HORSHAM DISTRICT COUNCIL CONSULTATION

TO:	Horsham District Council – Planning Dept
LOCATION:	Land To The South of Broadbridge Way Broadbridge Heath West Sussex (Wickhurst green)
DESCRIPTION:	Full Planning Application for the erection of 89no. residential dwellings comprising dwellings (54no.) and apartments (35no.), 36% affordable homes, creation of new vehicular access on to Sergeant Way, provision of public open space, landscaping and drainage solutions
REFERENCE:	DC/25/0894
RECOMMENDATION:	Modification
SUMMARY OF COMMENTS & RECOMMENDATION: 2nd set of comments Some of the previous concerns and comments have been addressed with thanks. With regards to those comments that haven't been addressed, where appropriate it is recommended that details are secured by condition. However, please note points 3c (avoid encroachment to existing trees rpa's), 5 (land budget) and 30 (surfacing material) are recommended to be addressed prior to determination. Point 13 is also recommend as being addressed prior to determination for clarity and given there are other issues to resolve, however we are fairly confident that landscape strategy can be delivered and this element of the proposal could be c

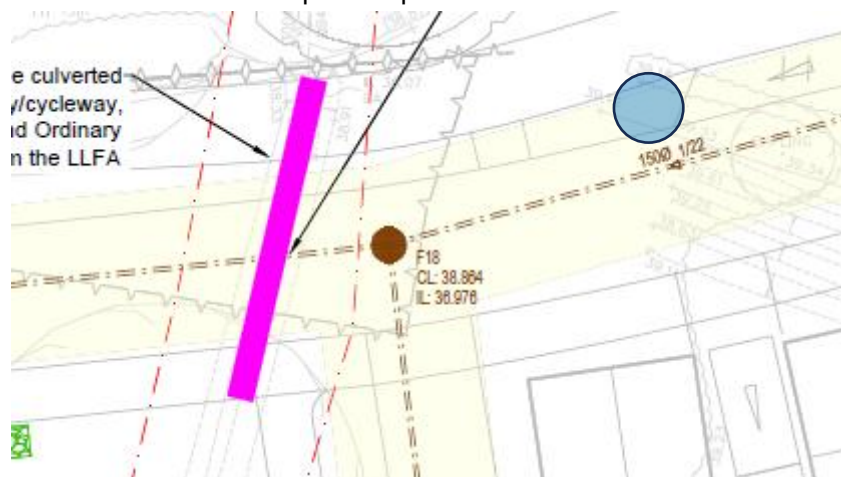
12. The SuDS proposals do not meet the full design criteria listed under 6.7.1 within the FRDR, with Amenity and Biodiversity notably missing from the proposed solutions.

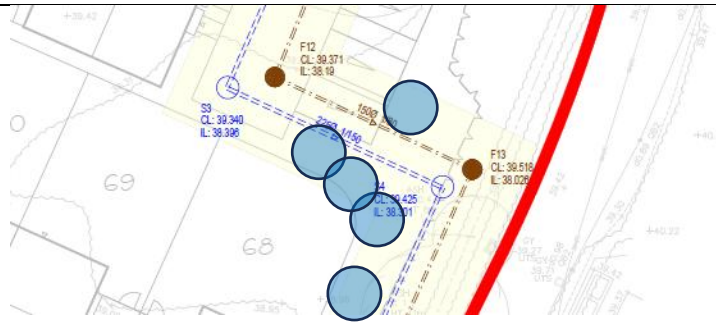
We note from the 'Technical Note Surface Water Drainage: Response to LLFA Comments' that, '*It has not been possible to provide SuDS across the site in order to intercept the first 5mm of rainfall for the majority of rainfall events due to development specific constraints*'. We do not concur with this statement and consider that there are further opportunities for SuDS that can be delivered on site, that also address the unmet design criteria of Amenity and Biodiversity. For example:

- a. Rain gardens, as noted under point 6
- b. Introducing blue green roofs to ancillary structures such as bin and cycle stores, which would be highly effective given their combined water collection area
- c. Wetland planting within the Open Space and/or alongside the stream and riparian buffer

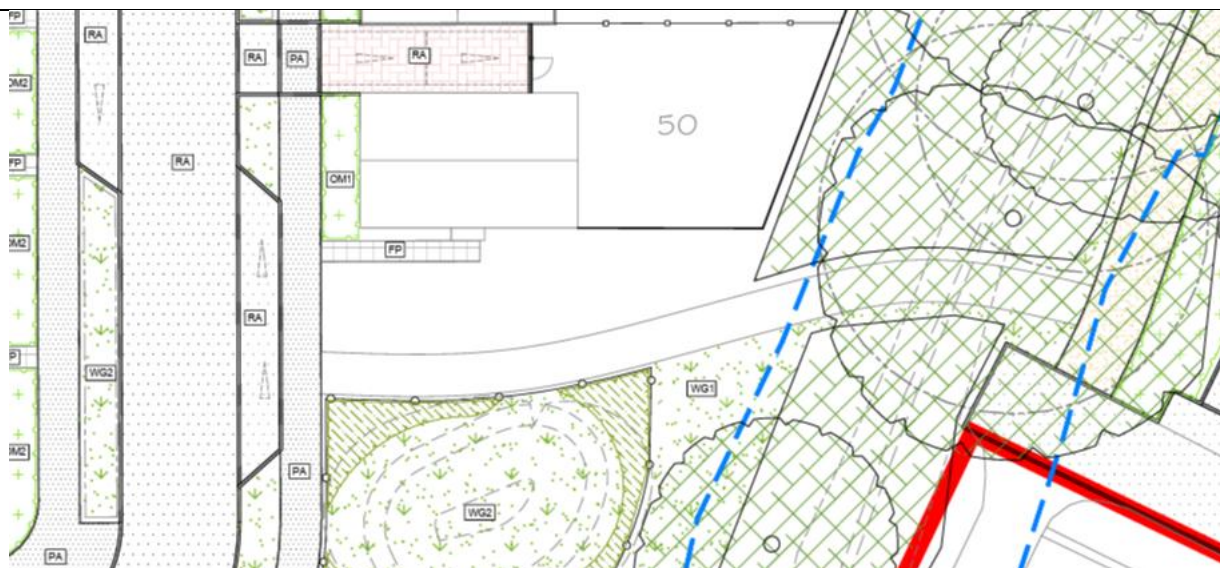
- 27. Please update the Boundary Treatments Plan (BTP) to reflect 'Landscaping buffer – hedges' as indicated in the key. **This has been added to the plans with thanks but are all the proposed hedges, including those in the front gardens to be 1.8m in height? This is not considered appropriate.**
- 28. Please provide specification for the brick boundary walls, noting that some level of brick detailing would be recommended for visual amenity and interest. **Not addressed, please secure by condition**
- 29. Post and rail fence should be added to the BTP for gardens alongside the central ditch, however this is not necessary if the layout is adjusted as per point 3. **Closed**
